**INQUIRY INTO IMPACT OF THE WESTERN HARBOUR  
TUNNEL AND BEACHES LINK**

**Name:** Mr Robert Newman

**Date Received:** 2 June 2021

**Re: Northern Beaches Link and Gore Hill Freeway Connection  
Environmental Impact Statement**

Image #1: Reserve Rd traffic suggestion

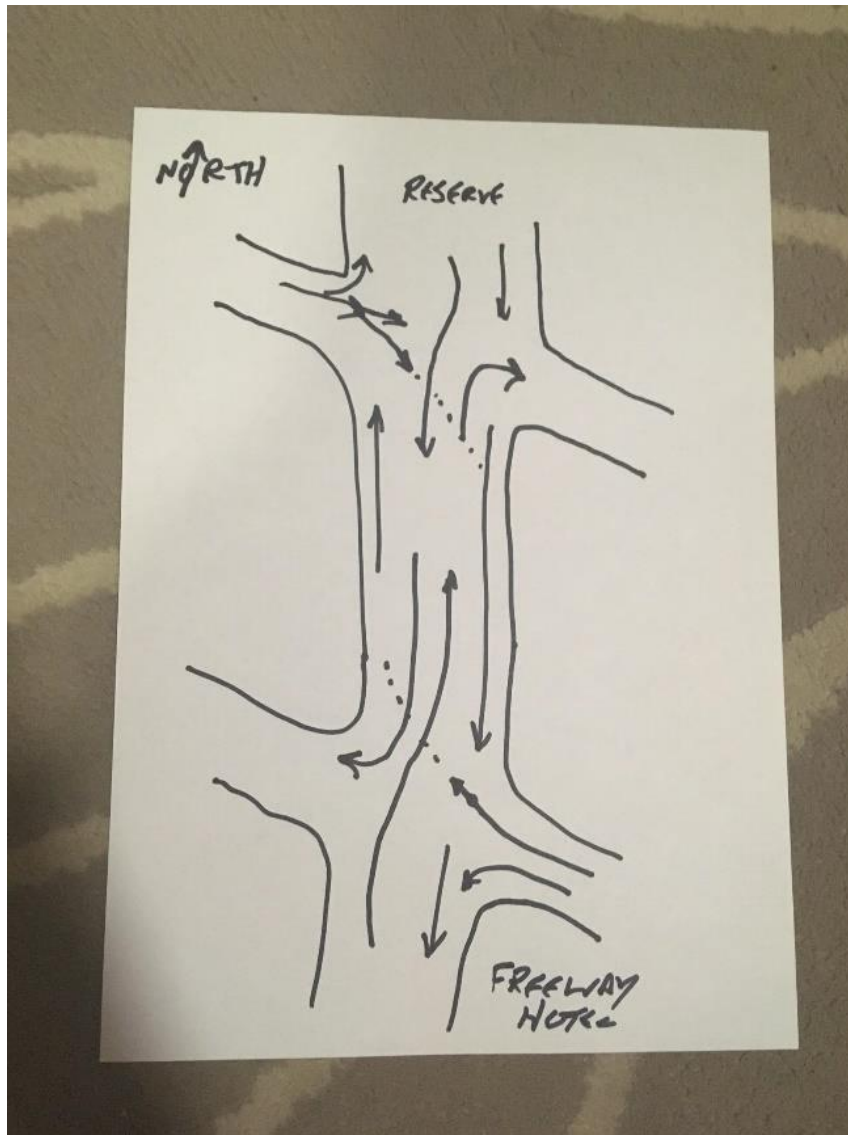
To alleviate this issue my suggestion is remove part of this cross over issue. Please forgive the crudeness of my diagram. (Image #1: Reserve Rd traffic suggestion)

A search of the internet tells me that this (Image #1 & #2) traffic intersection arrangement is a Contra Flow with Right Turn.

One can see the similarities between the above diagram (Image #2) and the existing Reserve Rd bridge intersection.

Any solution for this intersection needs to include consideration of the existing roundabout on Barton Rd as this provides a limited in peak hour south bound traffic flow and as such also limits departing traffic north bound in peak times.
